To: Township Board  
From: David Rohr  
Date: February 23, 2024

**RE: Preliminary Site Plan Application for General Planned Unit Development (GPUD23-001)** The proposed project will be built in two phases. Phase one will include a gas station building (5,475sqft) attached to a mixed-use retail/residential building, as well as a gas station canopy with twelve stalls (Parcel B). Phase two will include 40 for-rent Townhomes in eight buildings with between 4-7 units in each building and a 1,400 square foot community center/office management building. (Parcel A)

**To:** Planning Commissioners  
**From:** David Rohr  
Hamburg Township  
Township Planner  
**Date:** February 21, 2024  
**Agenda Item:**  
**Project Number:** Preliminary Site Plan Application for General Planned Unit  
Development (GPUD23-001)  
**Project Location:** 76200 M-36 and 10303 Hamburg Road  
**Owner:** Ronny Hamama  
**Applicant:** Ronny Hamama

**1** Tree Removal and Preservation Plan  
SCALE: 1/8" = 1'-0"  
NORTH

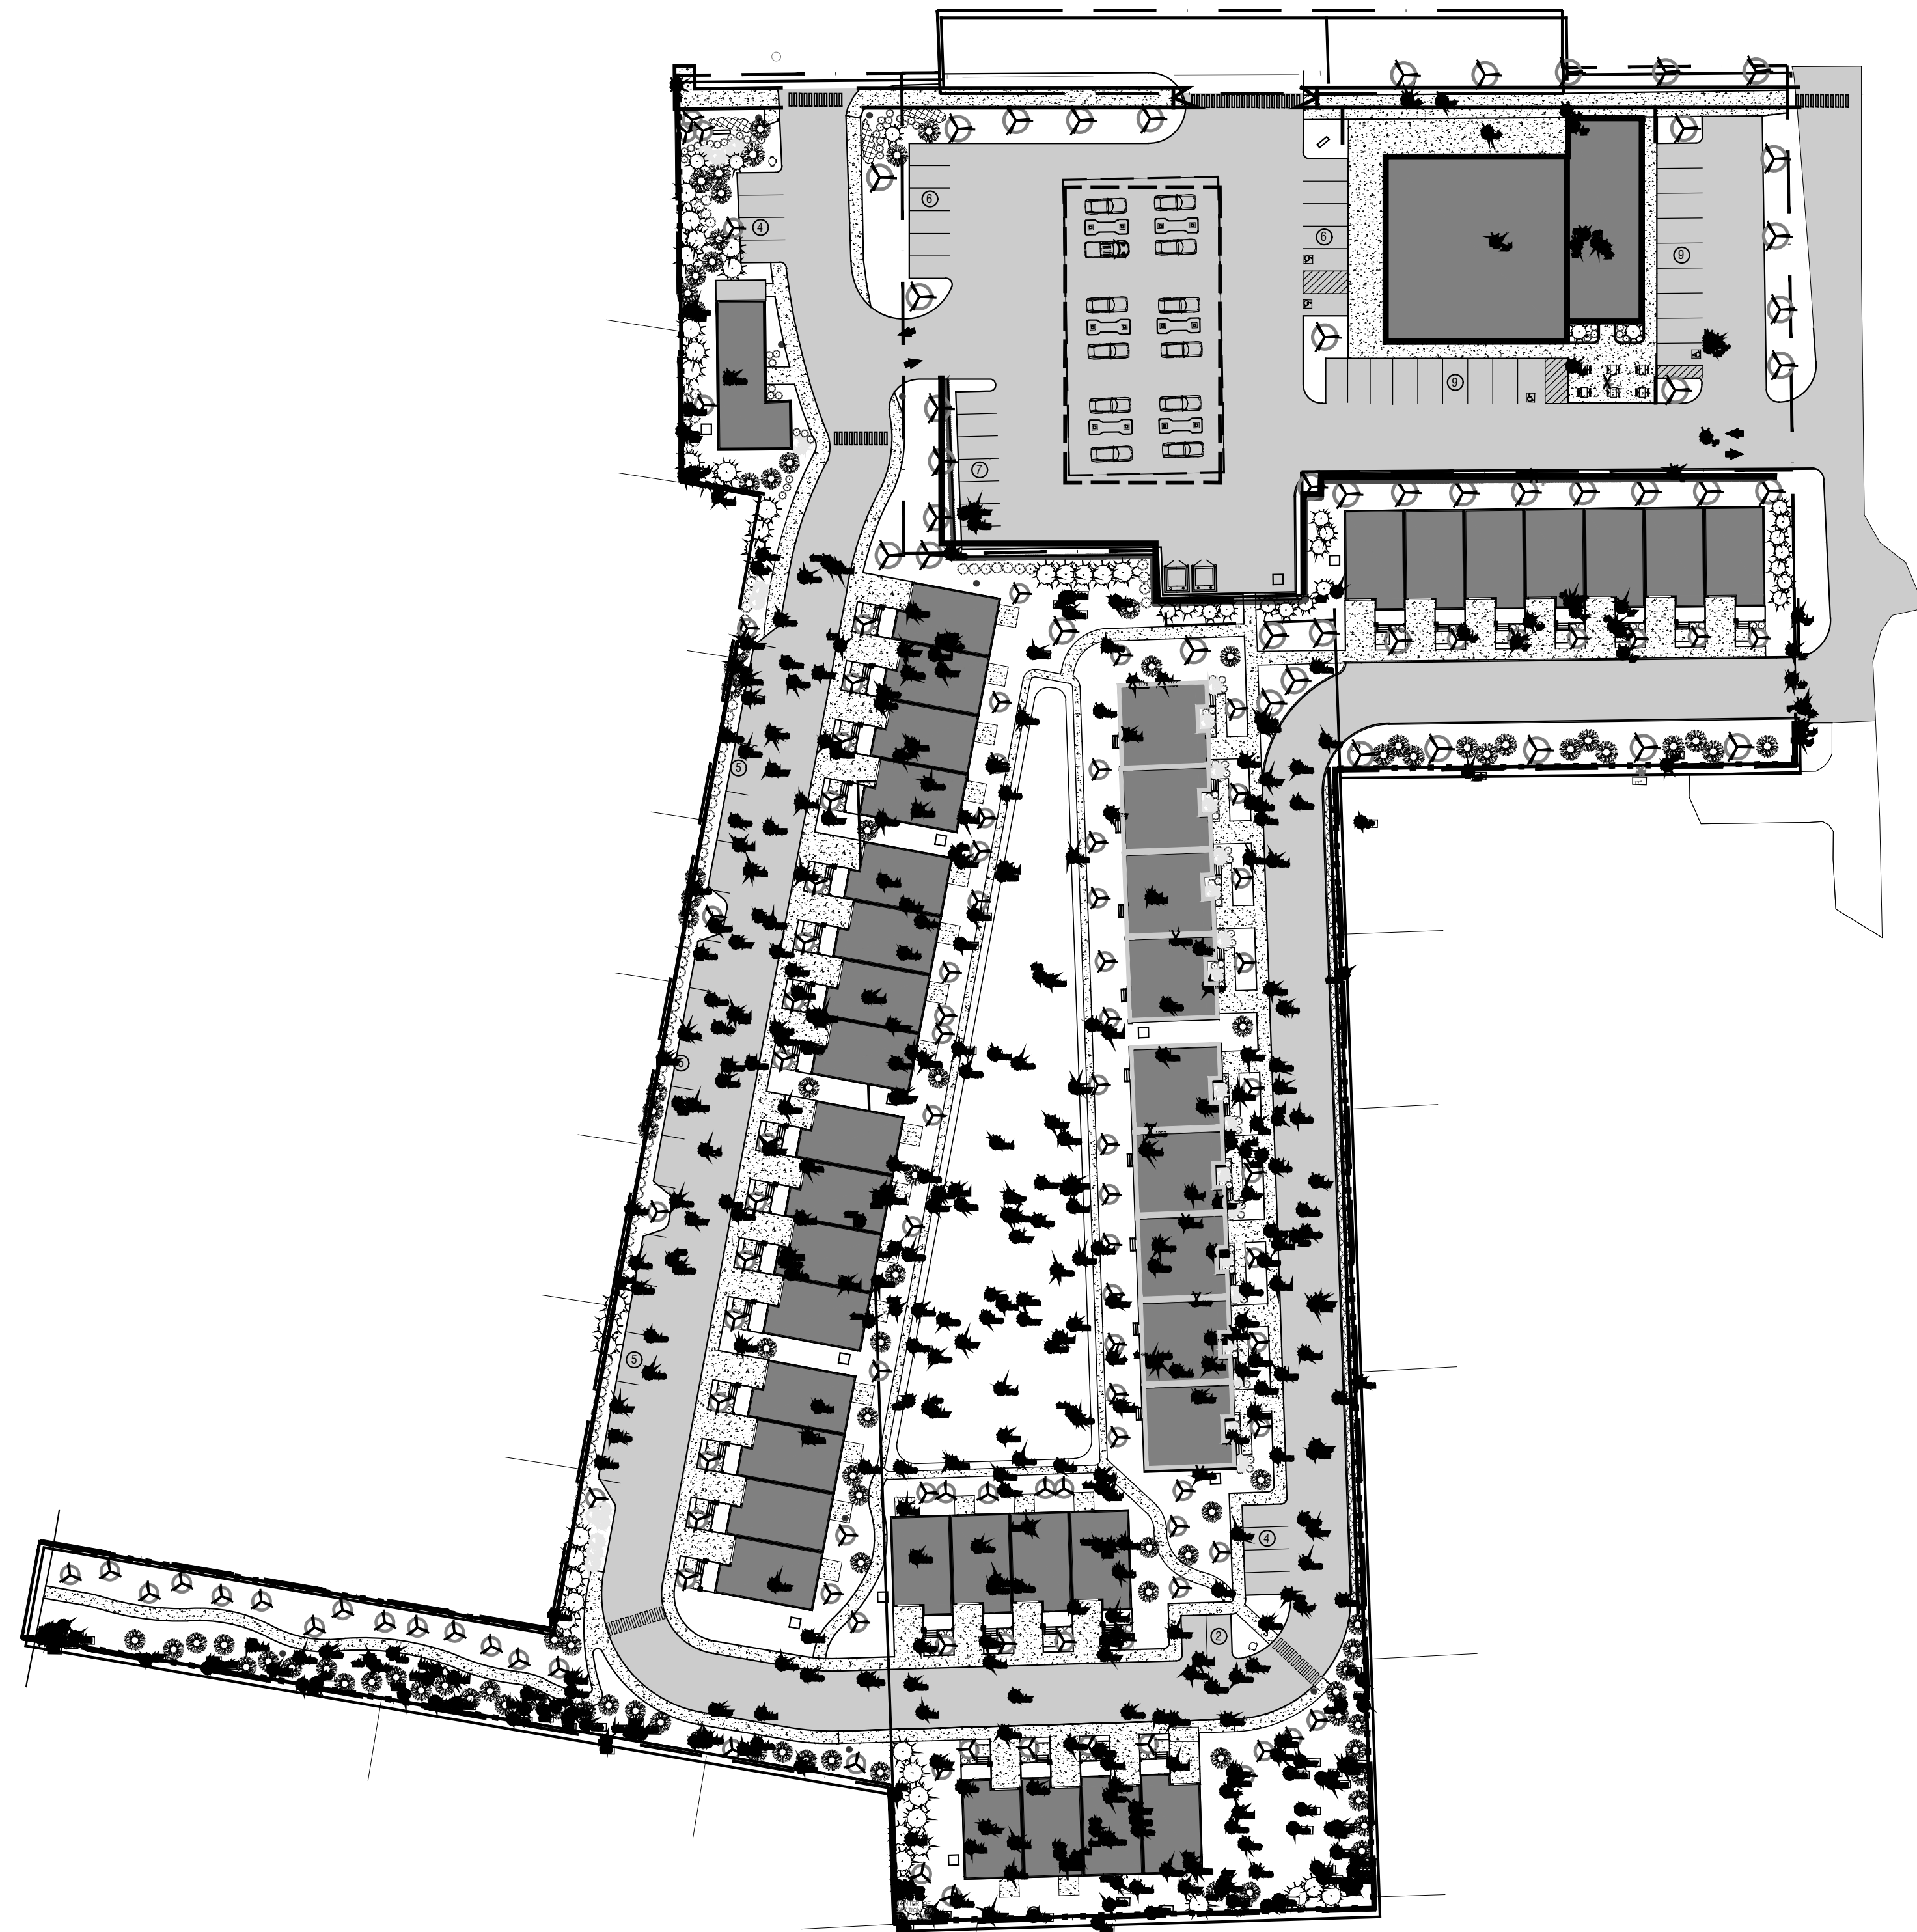
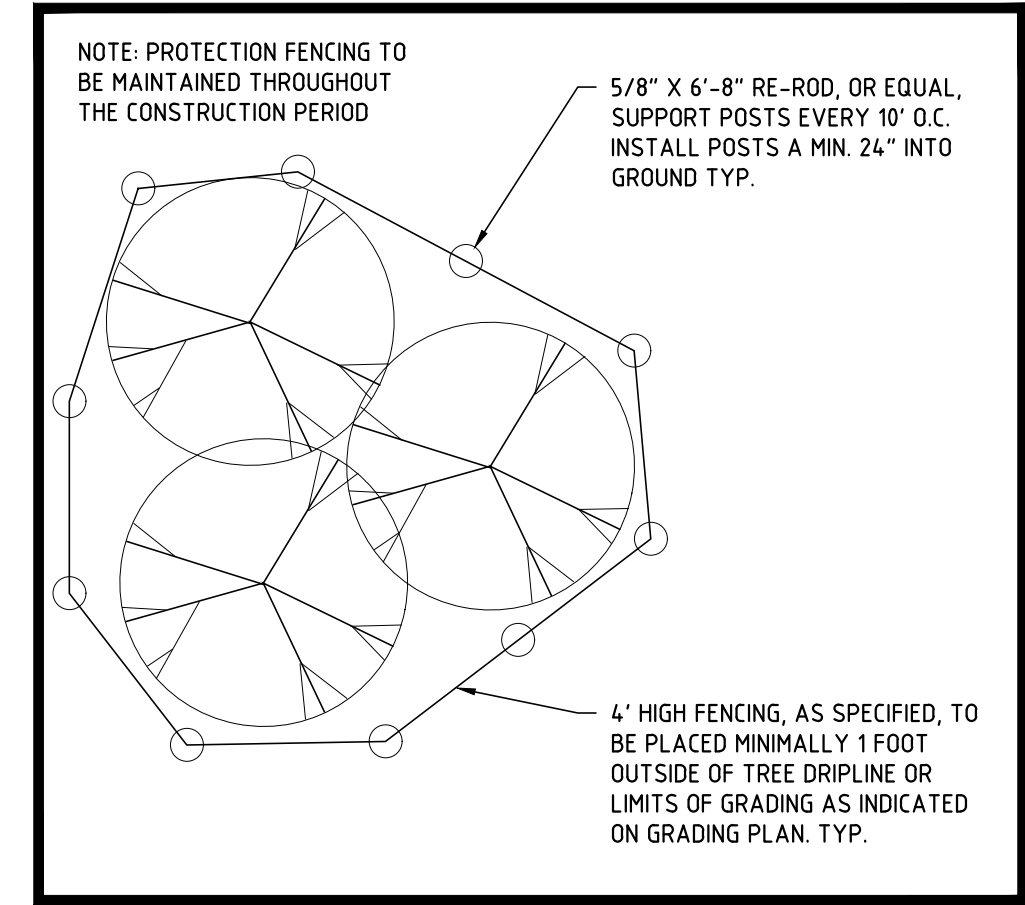
The preliminary plan provides a tree removal plan and shows that many trees will need to be removed with a few existing trees to be preserved within the proposed open space park.

Plan Page L101: Landscape Plan shows conceptual landscaping including the existing trees to remain and proposed new trees.

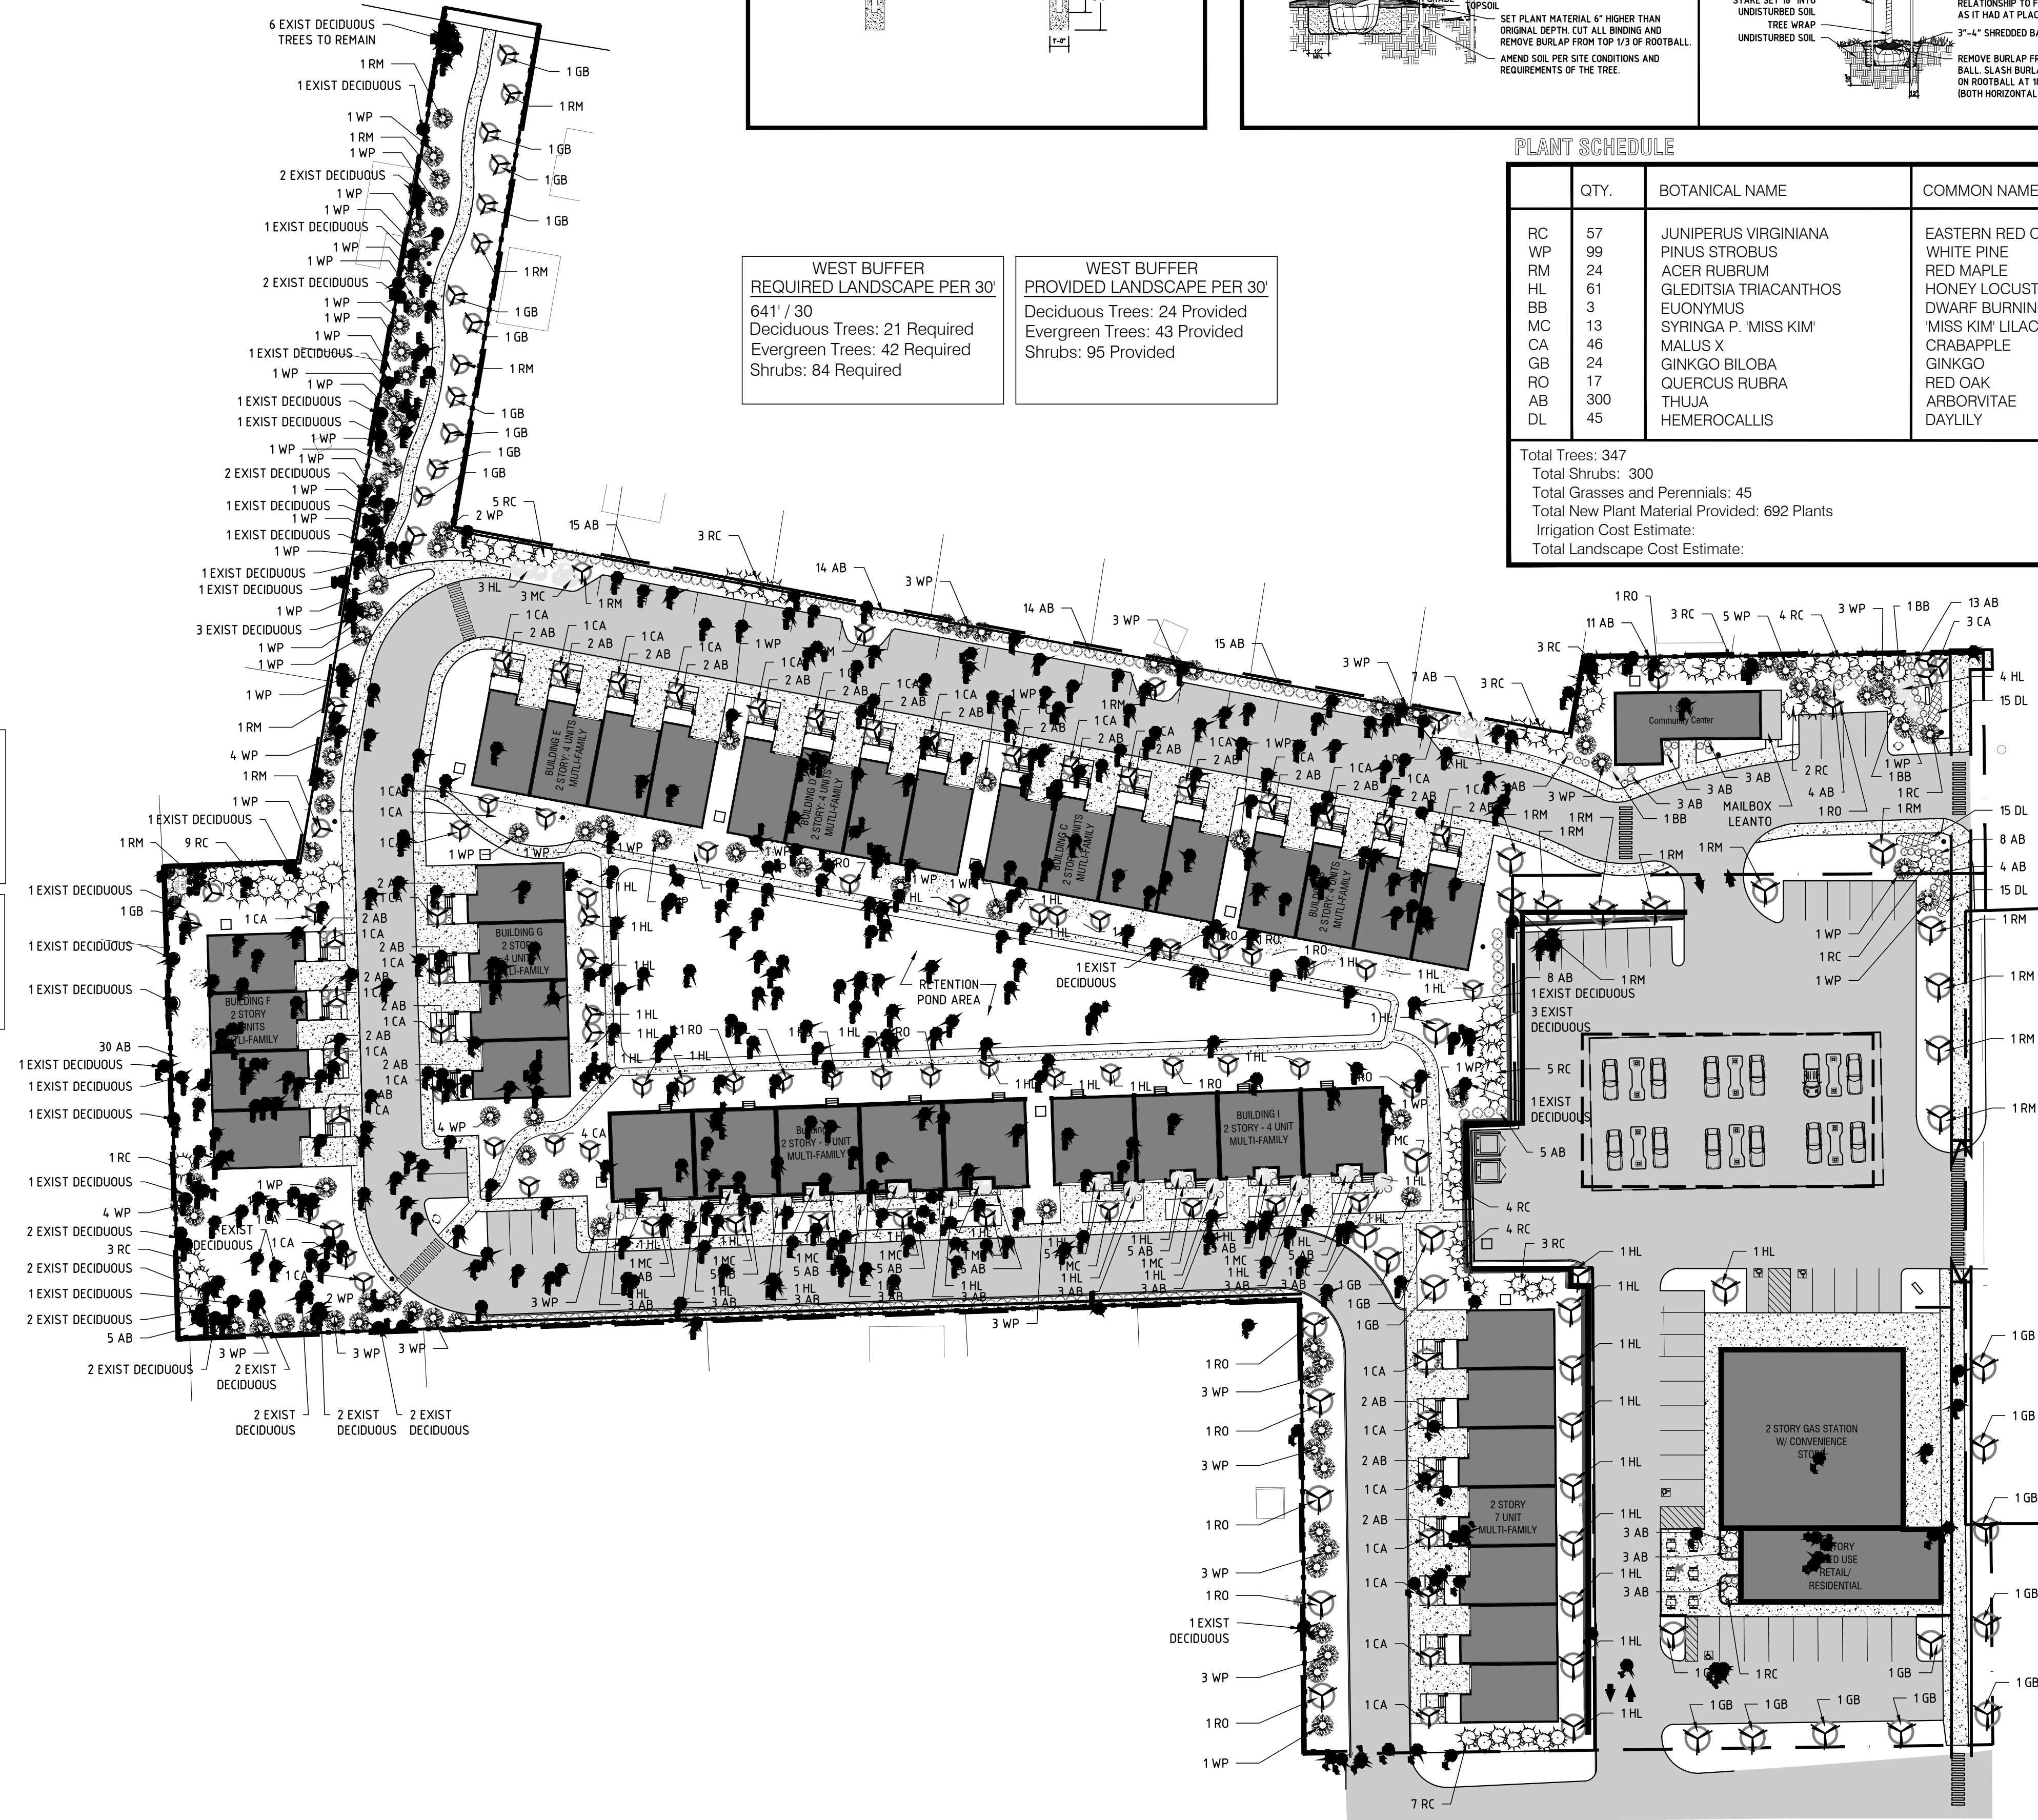
The landscaping plan details two buffer areas: west and south. Both proposed buffers provide more landscaping than is required. The entire site (sans M-36) is wrapped in a 6' wooden fence.

Little detail is provided for the M-36 or Campbell Ct. frontages. A more detailed plan would be useful for the final site plan review.

A more detailed landscaping plan that meets all the requirements. Applicant may also specify which landscaping requirements they wish to have waived.
